Response to October 19, 2023 Data Request

Bright Mountain Solar Project

Case No. 2022-000274

BRIGHT MOUNTAIN SOLAR, LLC'S RESPONSE TO STAFF'S October 19, 2023, DATA REQUEST

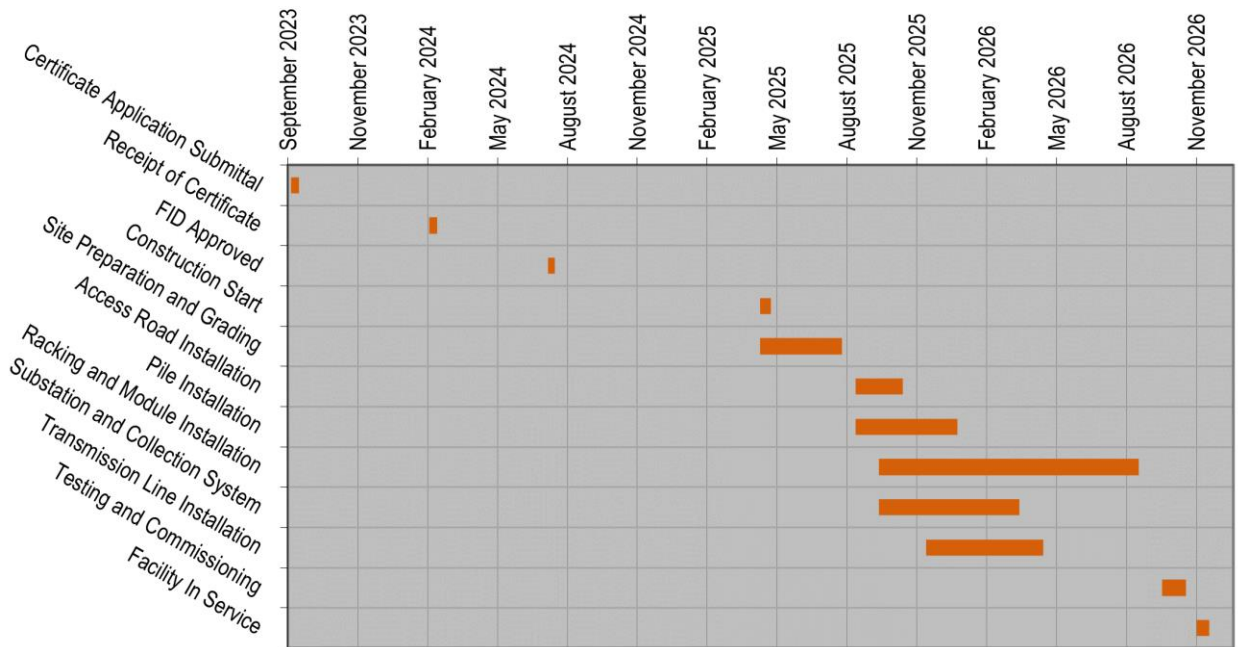
- 3. Provide a schedule for the project, starting from the receipt of the proposed certificate for construction to the completion of the project, including the length of each construction phase. Include in the response when Bright Mountain believes peak construction will occur within the timeline.**

A chart showing the anticipated Project schedule is below. Peak construction would likely be when pile driving activities begin through the installation of PV modules, anticipated to be approximately August 2025 to August 2026.
